# Interfaces & To-Do's

Silvia Verdú-Andrés – Brookhaven National Laboratory

9<sup>th</sup> HL-LHC Collaboration Meeting | FNAL, 14-16 October 2019

## 2) Func. Spec. Drawing(s!)

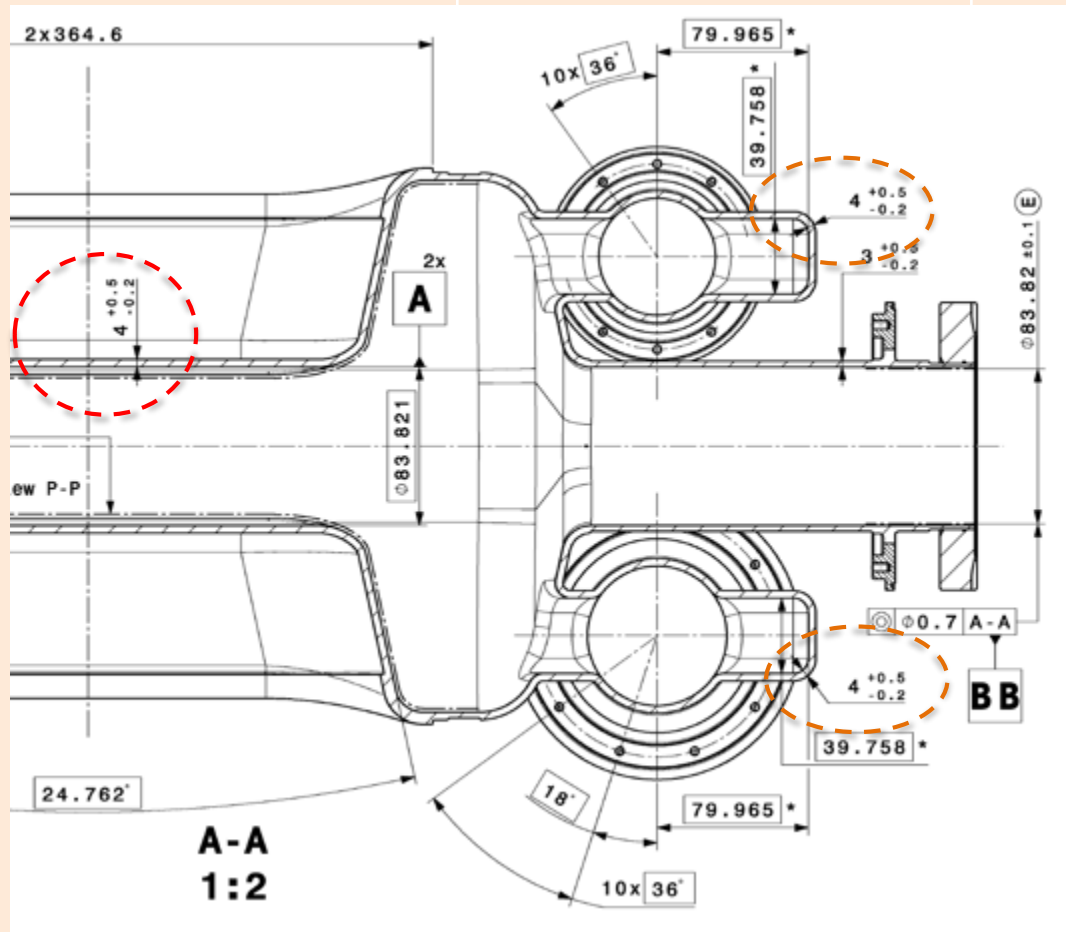
Increase tolerance band for corners of H-HOM waveguide box

Too tight, cannot reproduce in fab

## 9) The AUP deliverable

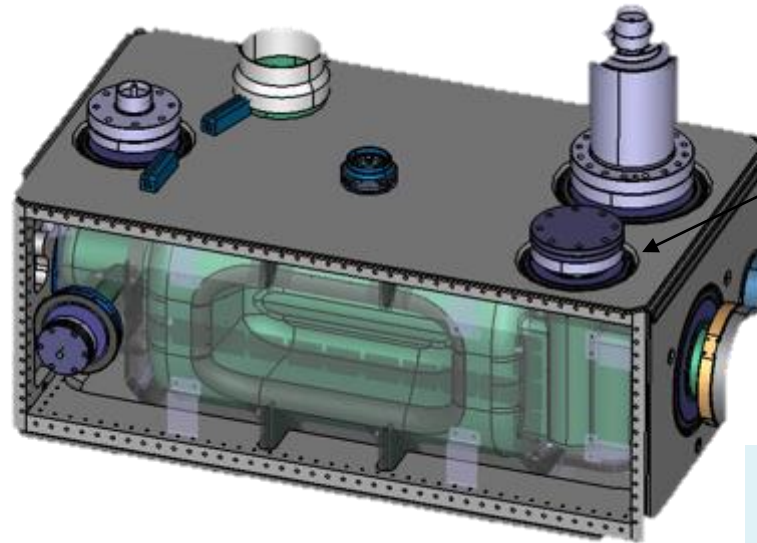
- Ship cavity **under vacuum, equipped** with input probe, right-angle valve and burst disk **ready for cold RF test**; protect openings.
- The delivery **also includes**: raw material coupons, welding/brazing samples, second beam pipe, two (2) cryoline tubes, two (2) tuning system bellows, mounting holes for various purposes.
- *Learned from dressed DQW cavity cold test*: **cracked feedthrough ceramics exposed to LHe. Strategy to avoid damage is under discussion.**

# Data interfaces per item (I)

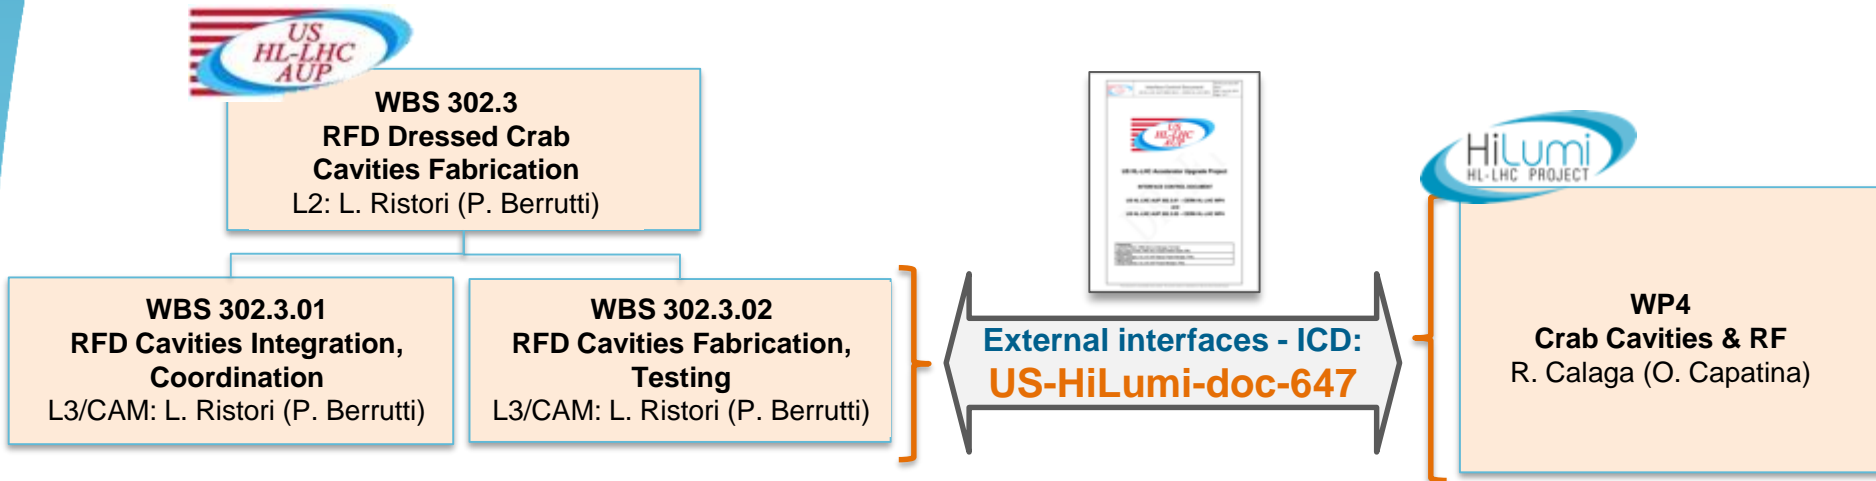
Feedback from Luca / Nuria on interfaces table:  
gather all corresponding tests under Non-Destructive Tests category
